# Mandatory Service Bulletin

## ENGINE COMPONENTS, INC.

S.B. No.: **03-7**

**Title: CYLINDER REPLACEMENT**

Photograph 1

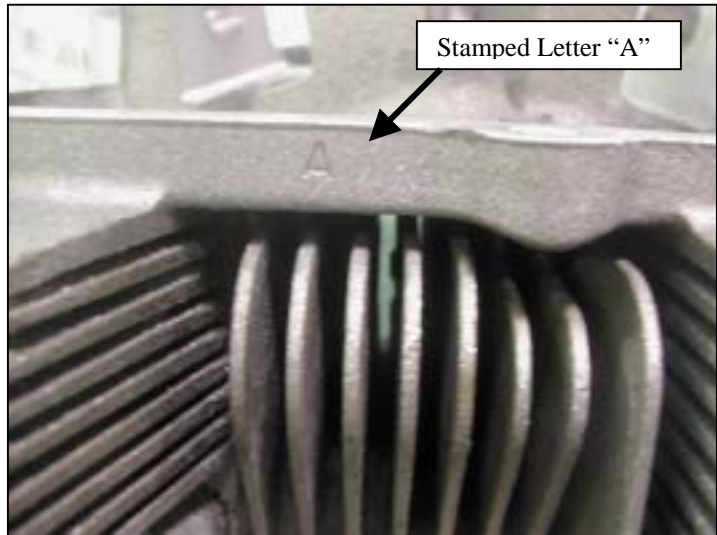
**NOTE: This Mandatory Service Bulletin applies only to cylinders P/N AEC631397 manufactured by ECi between Sept. 1, 2002 and April 21, 2003 and installed on the #6 position on TSIO-520 series engines of 325 HP or higher. These cylinders can be identified by removing the engine cowl and rocker box cover and determining if the logo is as shown in Photograph 1. If the cylinder head has the part number between the logo and rocker box flange and also has the letter “O” below the logo, then inspect the top of the rocker box flange above the logo (view while looking down on the cylinder) and determine if a letter “A” is stamped on the rocker box flange as shown in Photograph 2. If the cylinder head is stamped with the letter “A”, then record this inspection in the engine logs and no further action is required. If there is no letter “A” stamped on the cylinder flange, call ECi Customer Service to Schedule cylinder replacement.**

- a. Determine that the engine is a TSIO-520 that has been approved for operation at 325 to 335 HP.
- b. Remove the engine upper cowl and release the left side cowl and allow it to hinge down. Remove the rocker box cover from the left front cylinder. Determine if the left front cylinder casting is an ECi Part No. AEC65385 replacement cylinder as shown in Photograph 1. Verify that the cylinder head marking is identical to Photograph 1, with the part number between the ECi logo and the rocker box flange. Also, the letter “O” will be below the logo as shown.

- c. If the cylinder is identified as an ECi replacement cylinder with the identification shown, then view the rocker box flange from the top of the cylinder. Determine if there is the letter “A” stamped on the rocker box flange as shown in Photograph 2. If the letter “A” is stamped on the rocker box flange, then no further action is required. Record the inspection in the engine logbook and return the airplane to service.

- d. If there is no letter “A” stamped on the cylinder head rocker box flange, then contact ECi Customer Service or your overhaul facility to schedule cylinder replacement at no charge to the owner/operator. ECi will send replacement cylinder assemblies to the owner/operator for change and pay reasonable costs for the cylinder change.
- e. All removed cylinders must be returned to ECi for evaluation. Additionally, please provide details of cracked or broken cylinder heads to the FAA’s Fort Worth Aircraft Certification Office (Mr. Richard Karanian, SW-190, 817-222-5195).
- f. Any alternative method of compliance to this Mandatory Service Bulletin should be evaluated by ECi Engineering before accomplishment. Accordingly, contact ECi Customer Service to schedule consultation with ECi engineers.
